HOLDOVER

WICKER SUBDIVISION

APPLICATION NUMBER Holdover DATE August 19, 2004

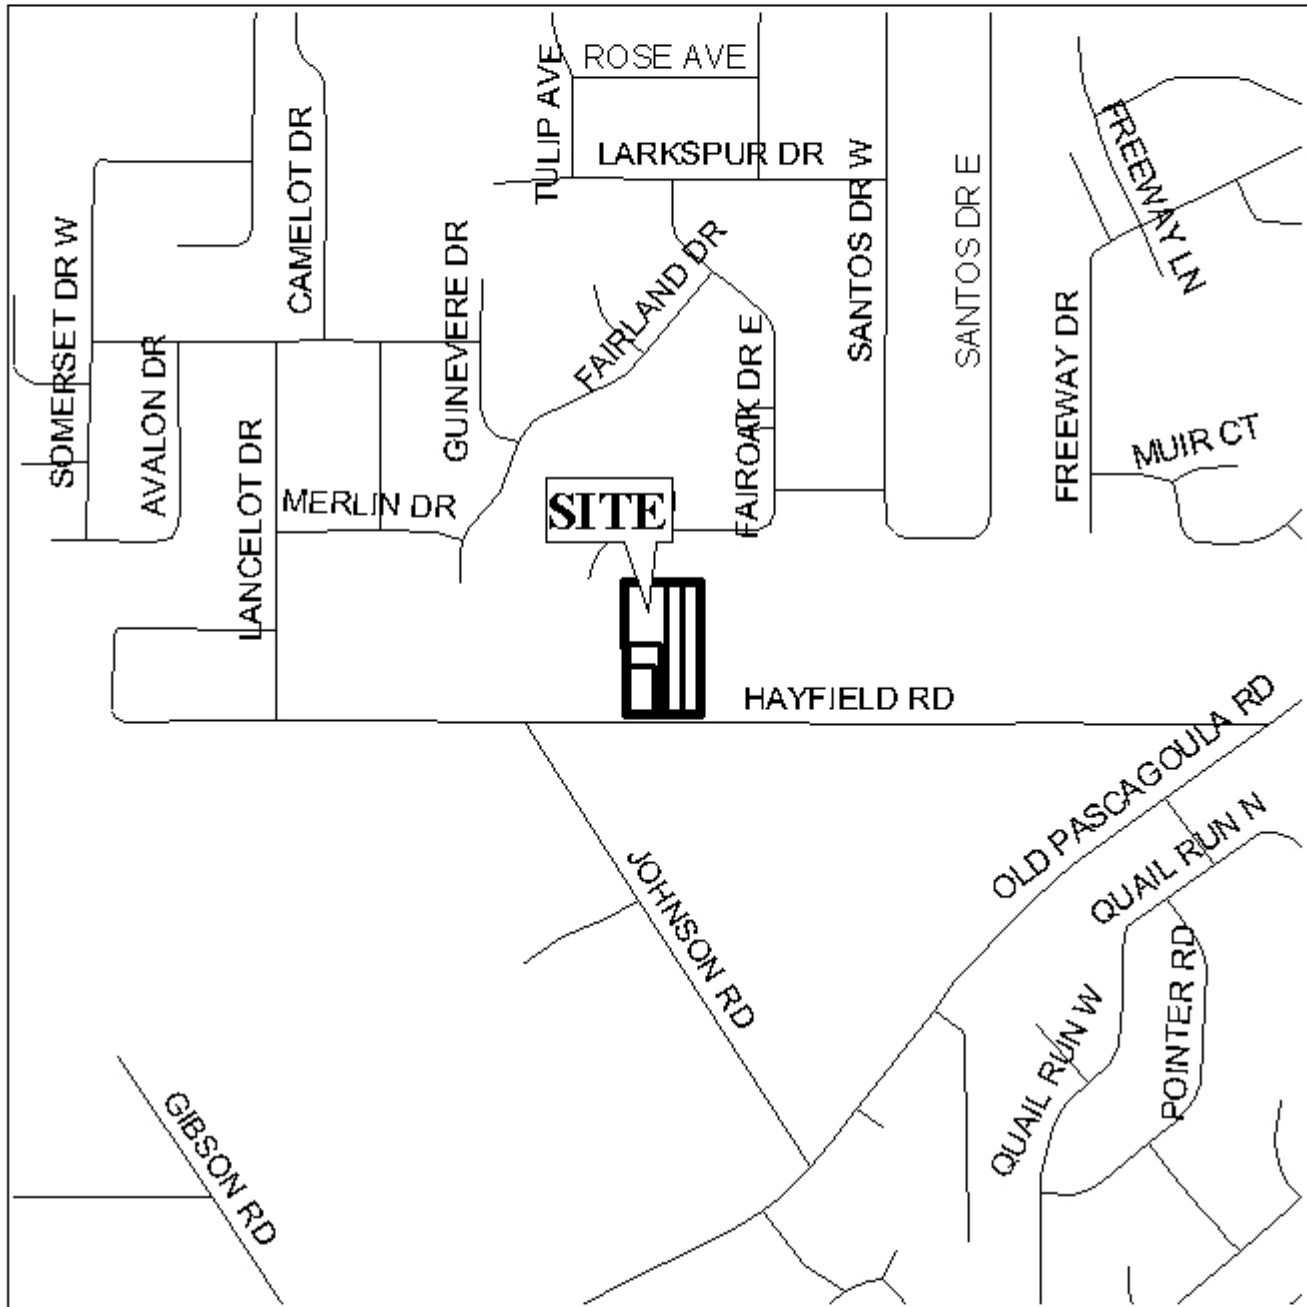
The 25-foot minimum building setback lines are not shown but would be required on the final plat.

As proposed, Lots 2, 3 and 4 are flag shaped lots that have only 25-feet of frontage on a public road, which would require a waiver of Section V.D.3. (width to depth ratio) of the Subdivision Regulations. Given the number of flag shaped lots and size of the property, dedication and construction of a street would be appropriate, especially given the size of the flag shaped lots and their potential for resubdivision. Furthermore, flag shaped lots are not characteristic with the surrounding area; therefore, Section V.D.3. should not be waived.

The applicant submitted a revised plat reducing the number of flag shaped lots in the subdivision from three to two and reconfigured Lots 4 and 5.

As proposed, Lots 2 and 3 have only 25-feet each on a public road. A note should be placed on the final plat stating that there can be no future resubdivision of Lots 2 and 3 until additional frontage is provided on an open and maintained public right-of-way. Moreover, a note should be placed on the final plat stating that both lots are limited to one shared curb cut to Hayfield Road, with the size, location and design to be approved by County Engineering.

Additionally, Lots 2, 3, 4 and 5 exceeds the maximum width to depth ratio as recommended by the Subdivision Regulations; therefore, a waiver of Section V.D.3., would be required.

With a waiver of Section V.D.3. (width to depth ratio), the plat will meet the minimum requirements of the Subdivision Regulations and is recommended for Tentative Approval subject to the following conditions: 1) the placement of a note on the final plat stating that any lots which are developed commercially and adjoin residentially developed property must provide a buffer, in compliance with Section V.A.7. of the Subdivision Regulations; 2) the placement of the 25-foot minimum setback lines on the final plat; and 3) the placement of a note on the final plat stating that there shall be no resubdivision of Lots 2 and 3 until additional frontage is provided on an open and maintained public right-of-way; and 4) the placement of a note on the final plat stating that Lots 2 and 3 are limited to one shared curb cut to Hayfield Road, with the size, location and design to be approved by County Engineering.
